Ford F150 SuperCrew

Replace Step 6 instructions with the following:

6

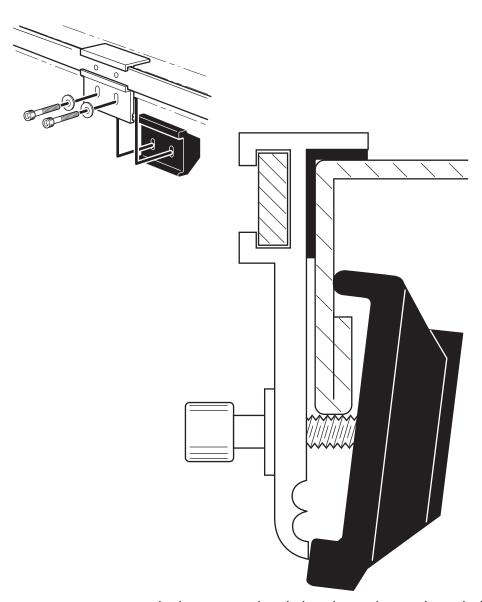
Attach clamp to each side bracket with two clamp bolts.

Clearance between bracket bolt and side wall rim the round bead does not fit in the bracket grooves. Invert the clamp so that the square bead contacts the lower lip of the bracket. It will rest securely on that edge.

Do not tighten at this step.
